MISSISSIPPI POWER & LIGHT COMPANY

SUBJECT: Grand Gulf Nuclear Station
Units 1 and 2
Docket Nos. 50-416 and 50-417
License No. NPF-13
File 0260/0272/L-860.0
Final Information to Close
Humphrey Concerns
AECM-82/574

Attachment 1 to this letter contains the balance of the information which Mississippi Power & Light Company (MP&L) committed in reference 1 to submit to your staff. This information completes the program which MP&L undertook to respond to the design questions raised by Mr. John Humphrey.

## ATTACHMENT 1

FIGURE 5-6

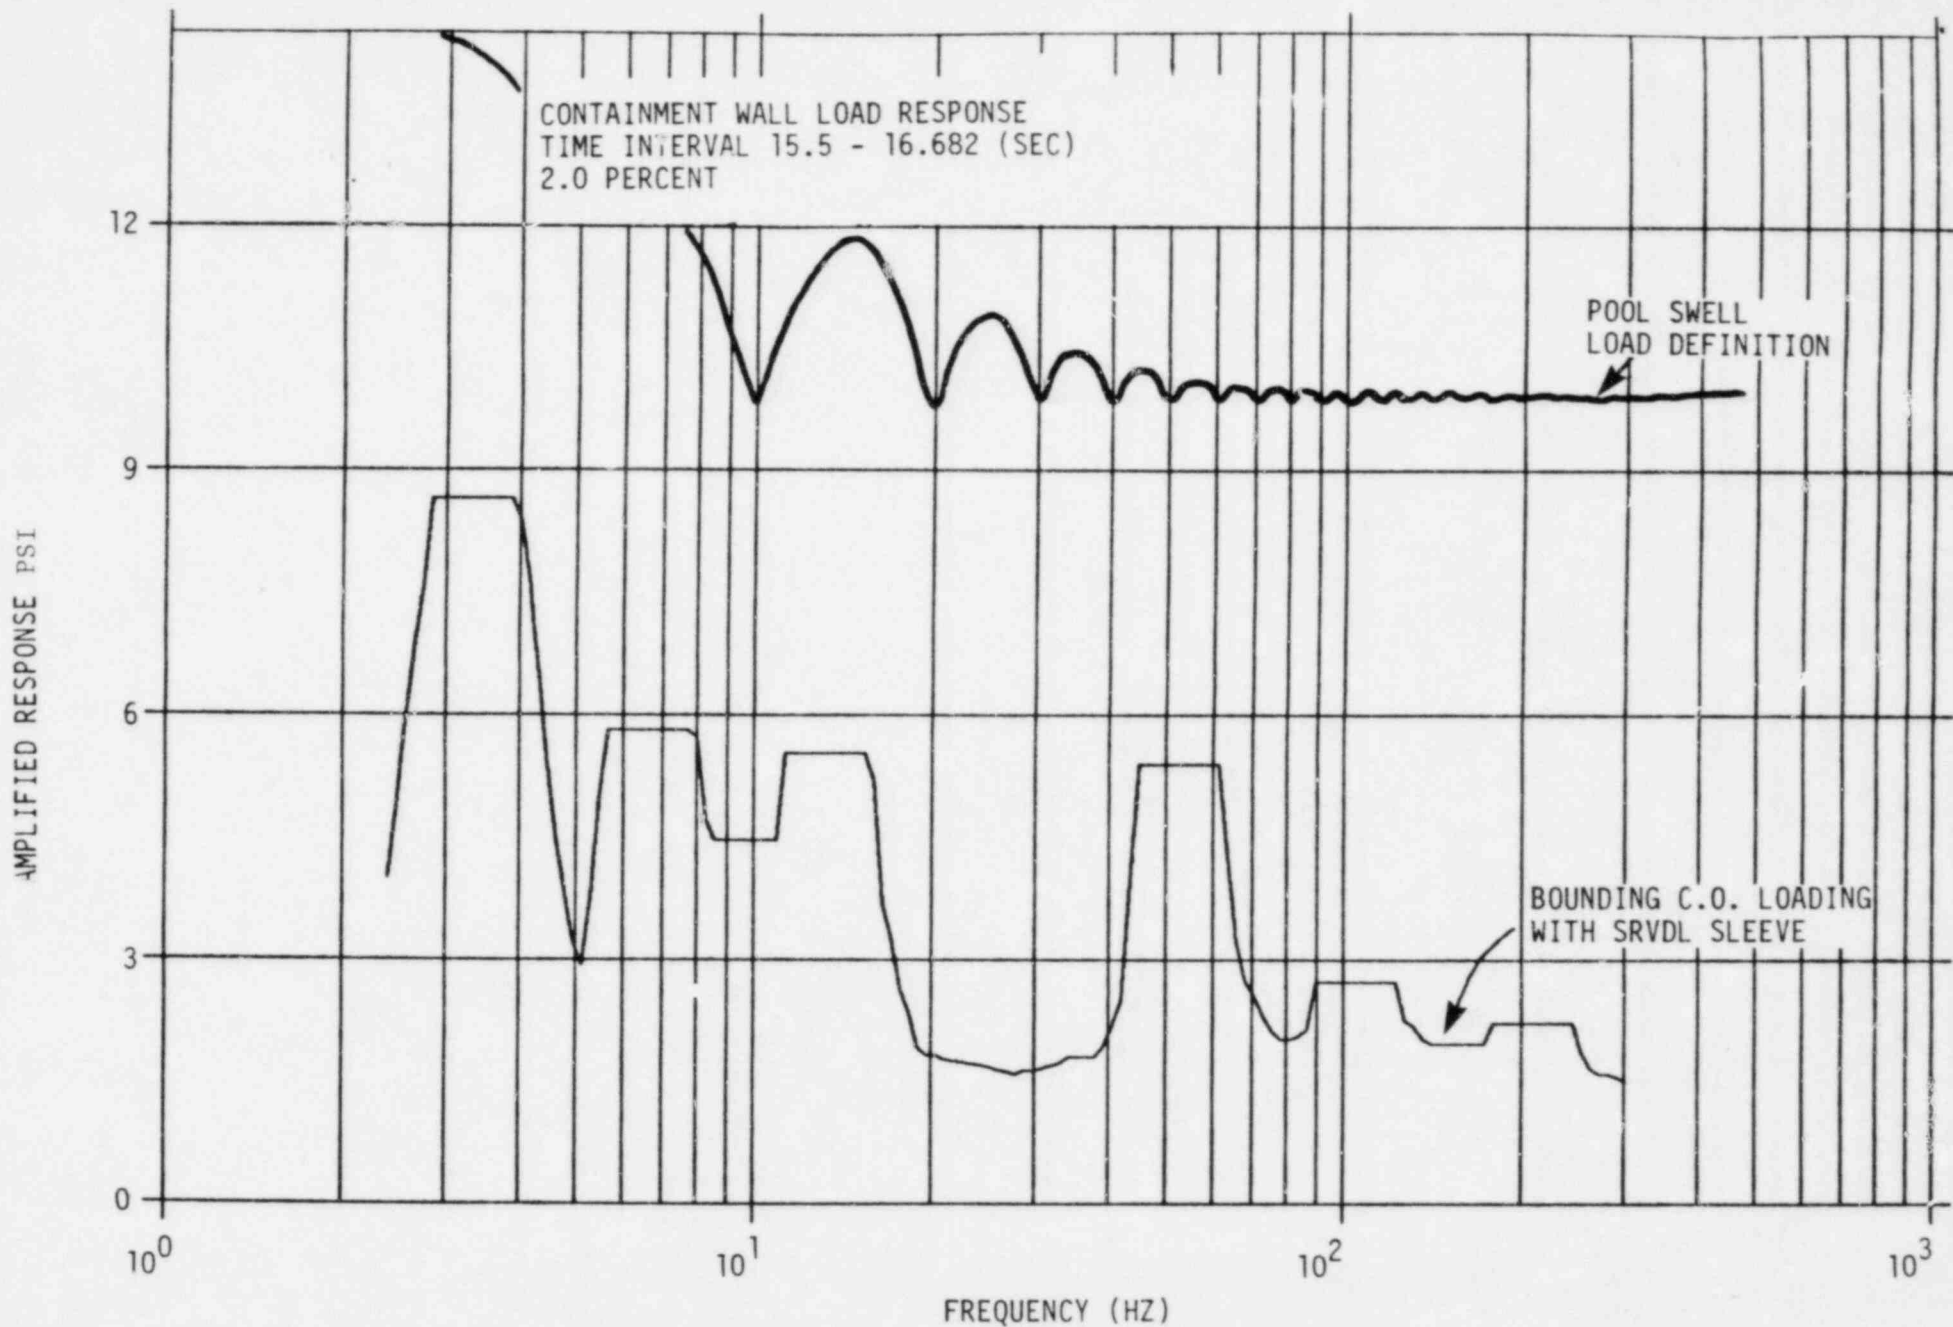
To determine the effect of the SRVDL sleeve C.O. on the containment wall loading, the drywell composite C.O. loading was attenuated to the containment wall. The resulting ARS is shown in Figure 5-6. As is evident from this curve, the ARS of the pool swell containment wall load definition bounds the combined effect of the main vent C.O. and the SRVDL sleeve C.O. Note that the global pool swell load is compared to the local SRVDL C.O. load, so the additional factor of conservatism previously discussed (on the order of 2) is present.

As shown in Figures 5-5 and 5-6, the presence of C.O. in the SRVDL sleeve vent creates new pressure peaks at frequencies of approximately 50 hz and 100 hz. These frequencies are considerably above the structural resonance frequency of the drywell and containment walls which is 13.55 Hz.

FIGURE 9-1  
JET FROM RHR RELIEF VALVE DISCHARGE

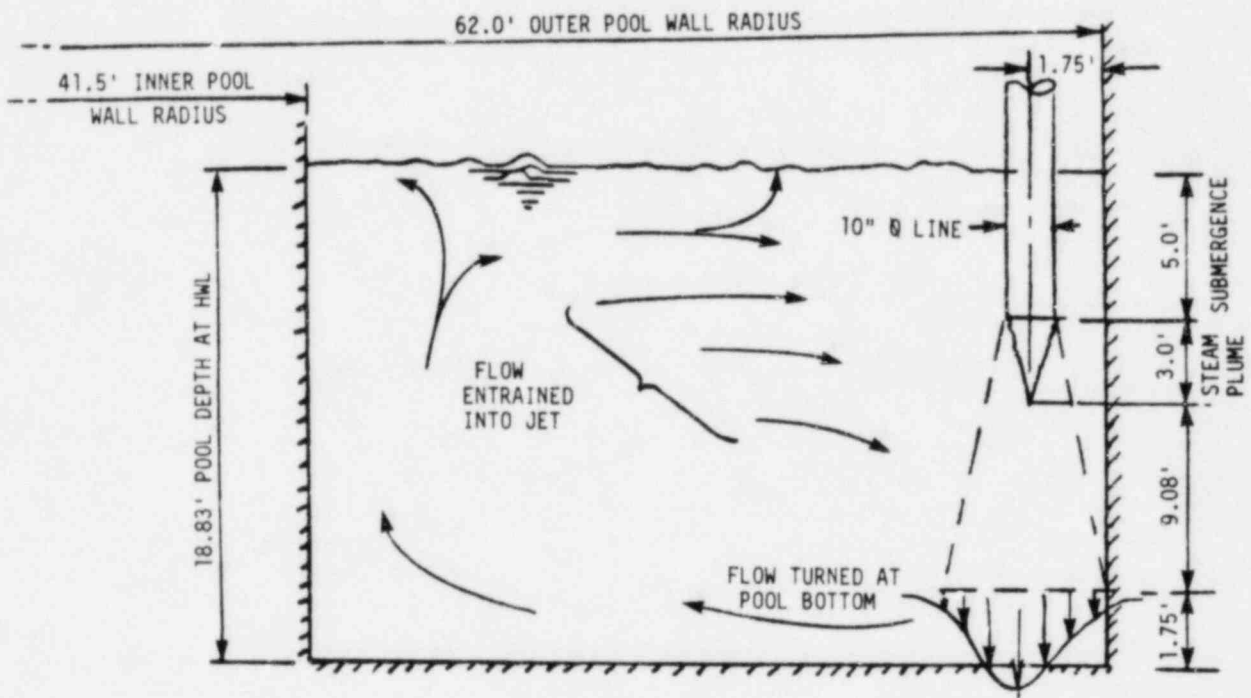
The postulated flow configuration is shown in Figure 9-1. Based upon the parameters calculated for an infinite pool, the appropriate parameters for the jet discharge in the finite suppression pool can be estimated.

FIGURE 9-2  
ISOMETRIC SKETCH OF JET DISCHARGE MODEL

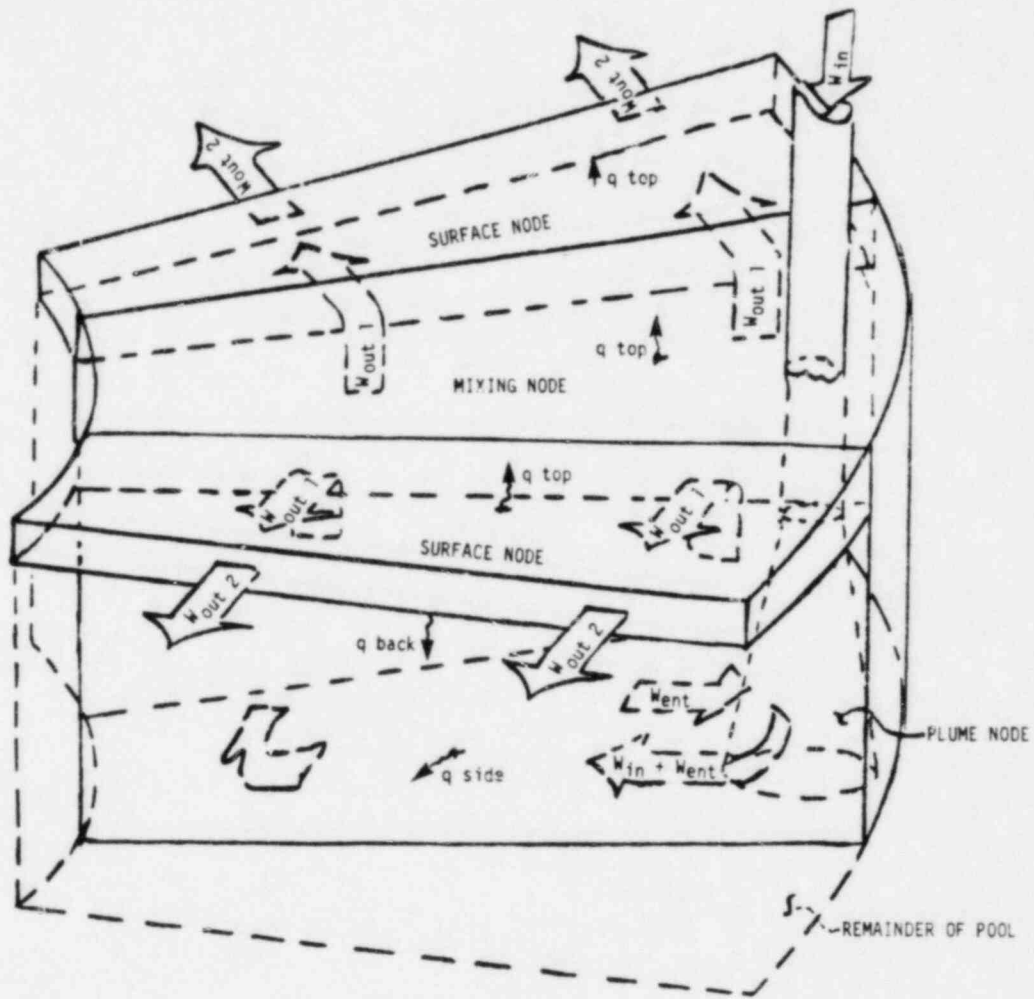
A drawing showing the nodalization used for evaluating the discharge from the jet is shown in Figure 9-2. A jet plume node ("jet node") is located within a local sector of the pool defined as the mixing node. The entrainment into the jet is assumed to be the same as for a free field jet between the discharge pipe exit and 1.75 feet from the pool bottom. Flow which is entrained into the jet will come from and be returned to the mixing node. The only flow leaving the mixing node will be the inlet jet flow minus the amount the mixing node grows due to an increase in pool depth as a result of jet flow addition. Flow from the mixing node will enter a series of surface nodes which will stretch around the pool. Because of the symmetry of the pool, only half of the pool is modeled.

FIGURE 9-3  
 POOL HEAT-UP DUE TO RHR HEAT EXCHANGER DISCHARGE

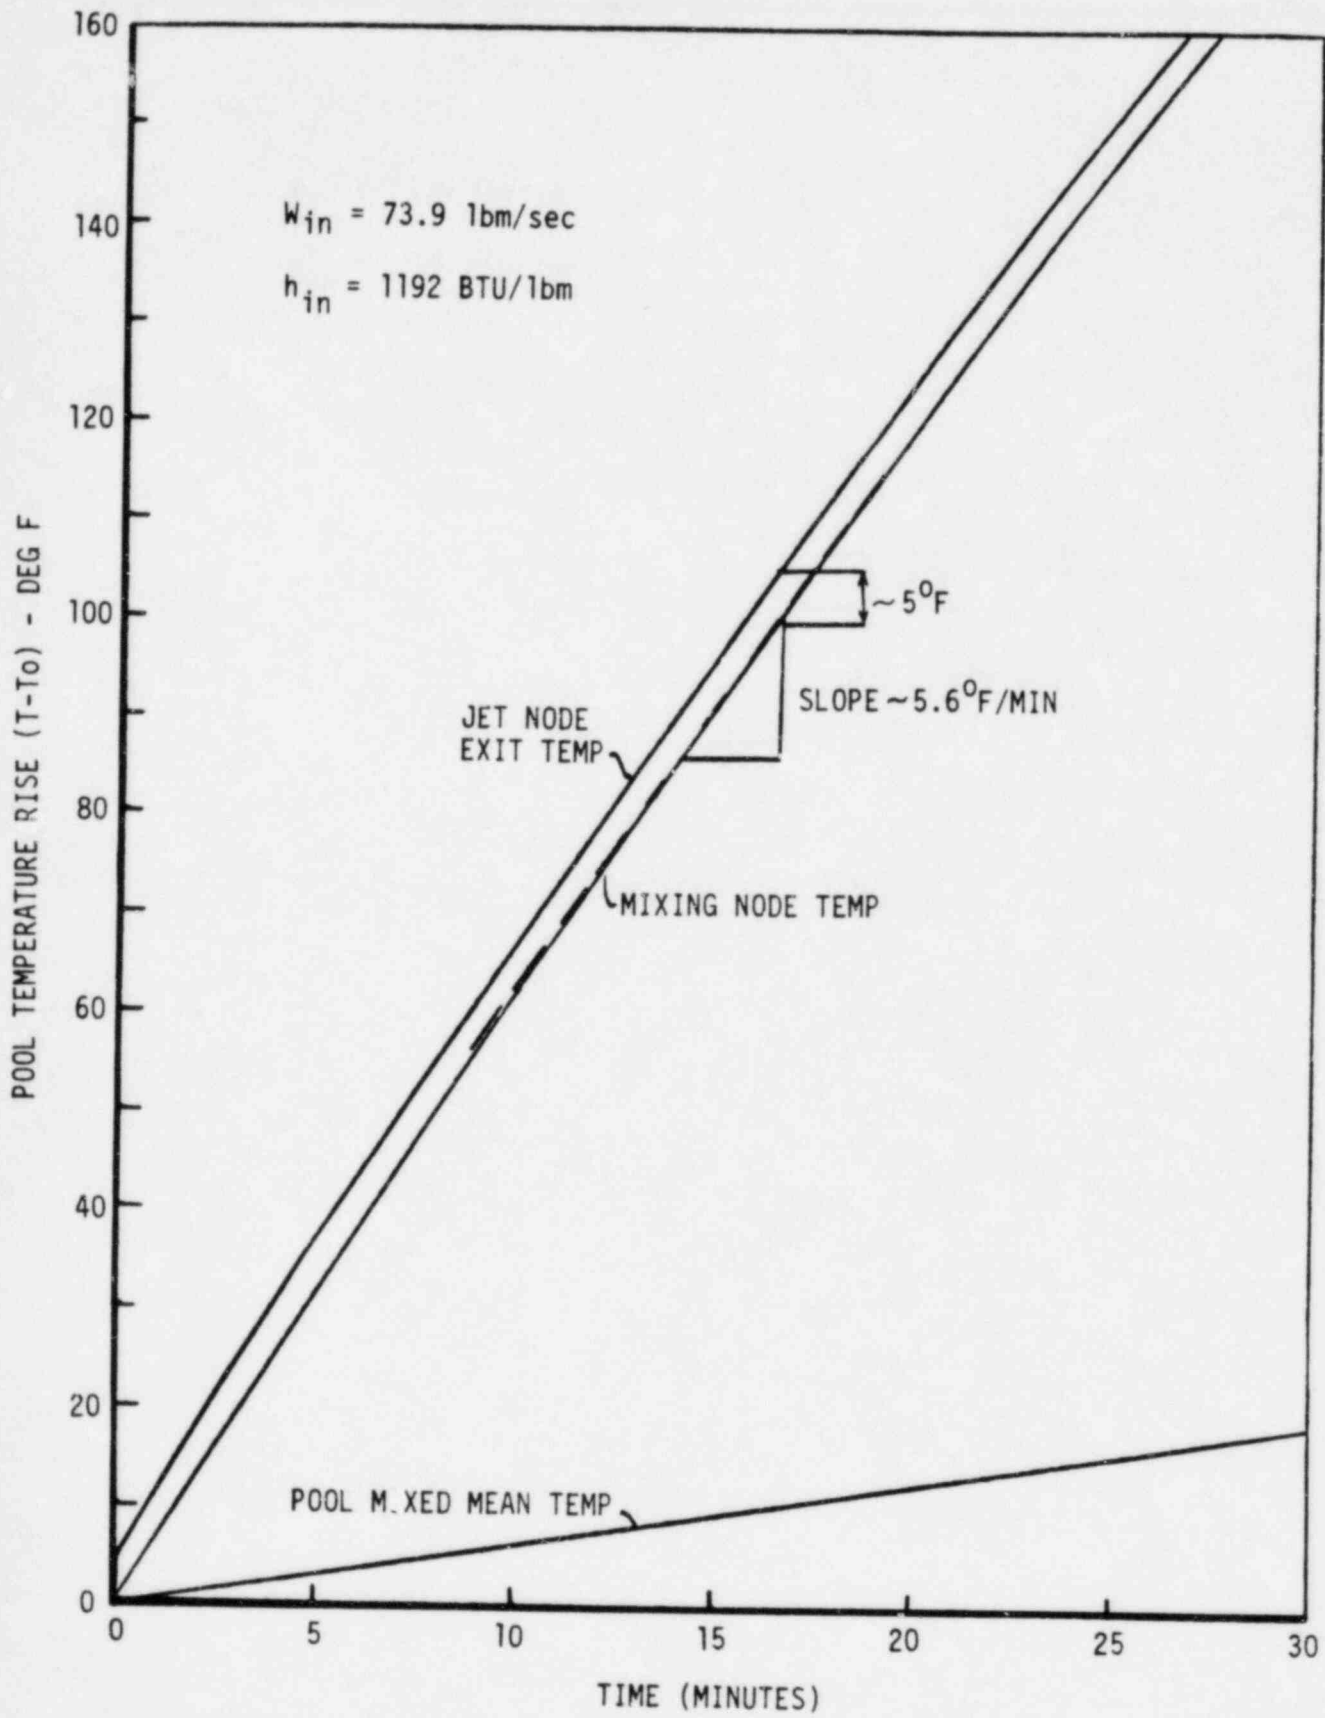
The predictions for jet node exit temperature and mixing node temperature as functions of time are shown in Figure 9-3. The mixing node temperature represents the local pool temperature surrounding the jet discharge. During the initial part of the transient, the mixing node temperature rise is not quite linear but

The most significant result from the model sensitivity studies is the confirmation that the size of the mixing node volume is the key parameter in the temperature predictions by the model. For the results shown in Figures 9-3, and 9-4, a mixing node volume was chosen such that the jet will mix the liquid inventory of the mixing node volume through the jet about once every minute. To demonstrate the effect of increasing this mixing volume size, Figure 9-5 shows the mixing node temperature history for various mixing node volume sizes. As this figure demonstrates, the mixing node temperature comes down rapidly as more of the pool becomes involved. It seems likely that as the RHR heat exchanger relief valve cycles open and closed, the turbulence produced by the starting and stopping of the steam jet will create sufficient mixing to involve a large sector of the pool. However, solving this complicated mixing problem would require a detailed nodal analysis of the transient jet in the pool.

FIGURE 9-4  
 POOL STRATIFICATION PROFILES

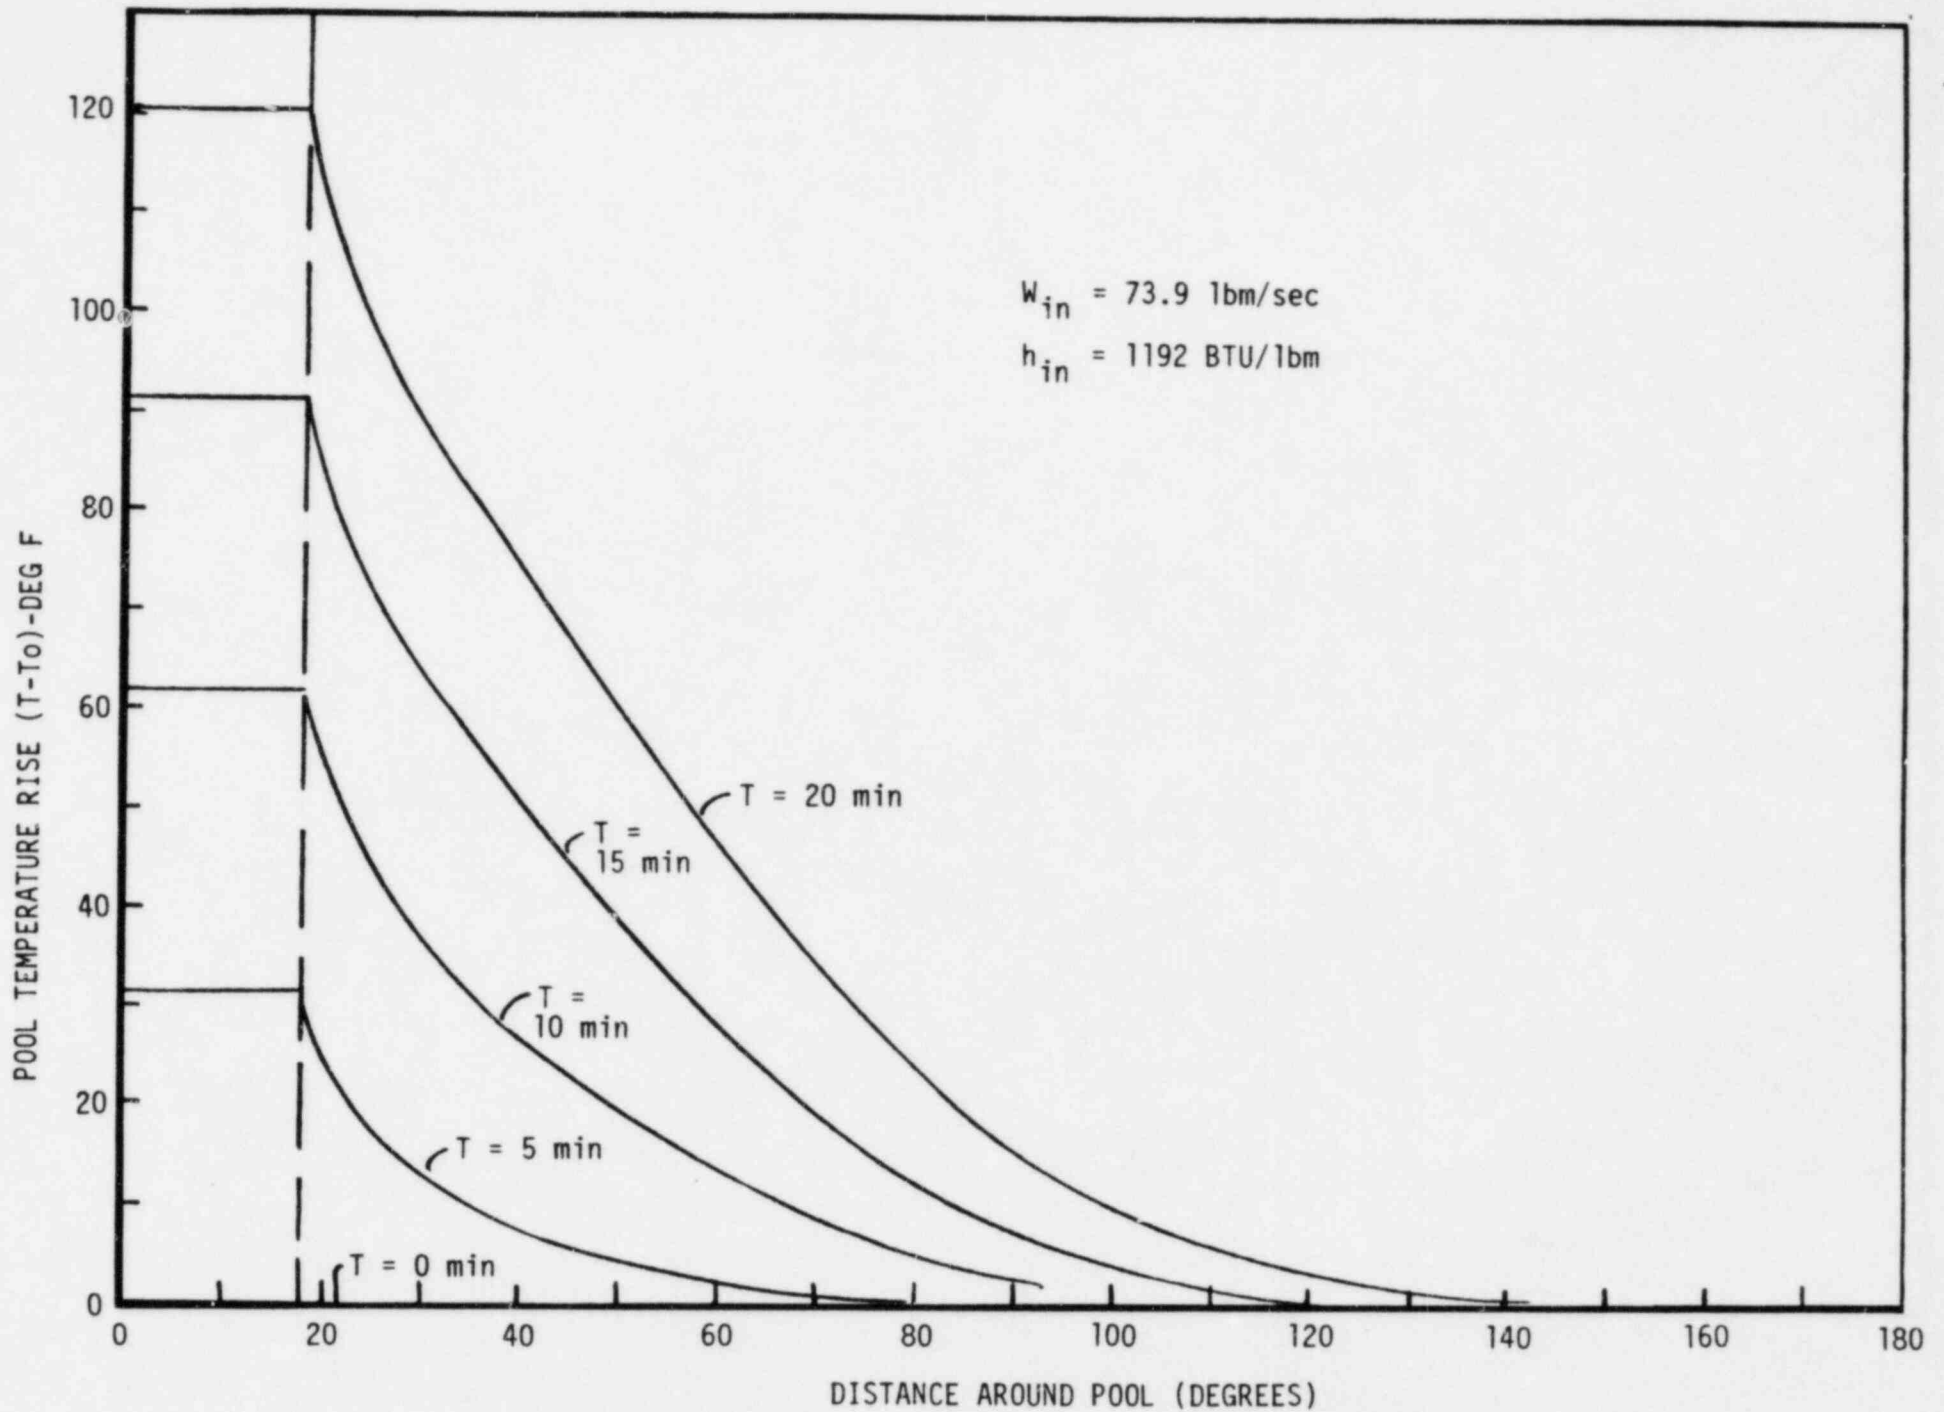
Figure 9-4 shows the predicted pool surface temperature stratification profiles. The stratification profiles are only important in terms of their effect on the average pool surface temperature since the containment air space temperature will only be affected by the average pool surface temperature. The average pool surface temperature rise at the end of 12 minutes will be about  $13^{\circ}\text{F}$ . For a fixed volume and fixed air mass above the pool surface, this temperature rise could at most increase the wetwell air space pressure by about 2% which is clearly inconsequential.
